CONDITIONS OF APPROVAL:

[Franklin Park Subdivision, site plan, revision 2, lot 8 \(Three Franklin Park Building\) - submittal 004.pdf](#)

28. Drainage

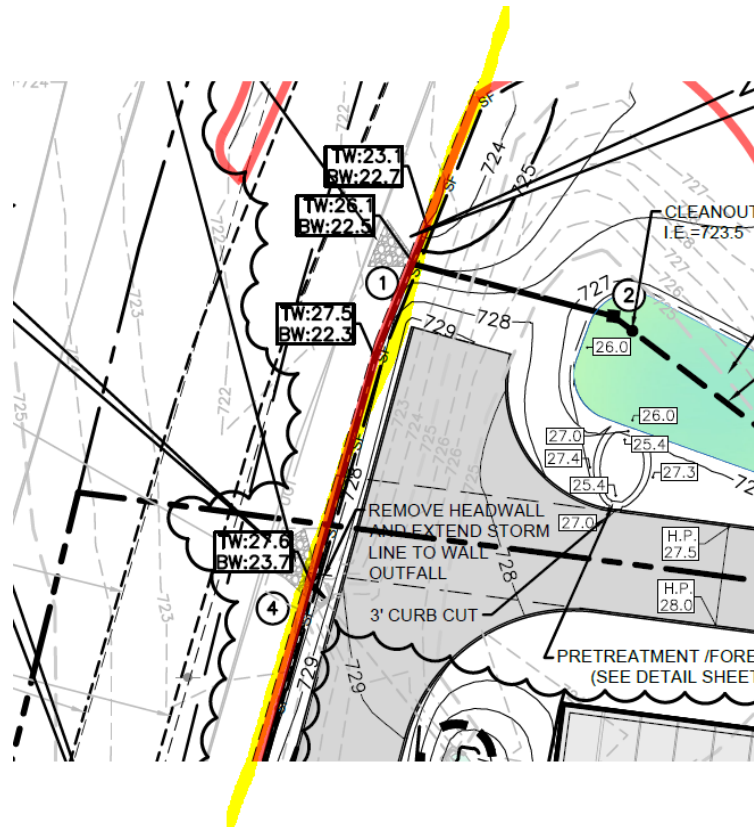
brittani.perez@franklintn.gov Grading has been shown to address drainage issues, but TDOT permission and drainage calculations have not been provided. Comment will remain open until items have been addressed.

Per onsite meeting, it was requested from Ragan-Smith to leave the area 'as-is', seeing as there was no ponding from previous rain events. This request was not accepted by City staff onsite, and was relayed that approval from the City Engineer will be required for this proposal, along with any other supporting documentation needed.

The options discussed were the following:

- 1. Provide positive drainage to the intended outfall and obtain TDOT permission for work within ROW. Provide all drainage calculations to show that outfall is sized appropriately to receive drainage from both Two and Three Franklin Park.*
- 2. Coordinate with Milcrofton to re-grade this area during waterline installation. Proposed work and grading shall be shown on site plan, as well as documentation of Milcrofton agreement to perform work.*
- 3. Hard pipe drainage to South Prong Spencer Creek, providing necessary treatment and dissipation required.*

Prior to One-Stop Approval, Applicant shall provide documentation for all work that is to occur and provide TDOT permission if required
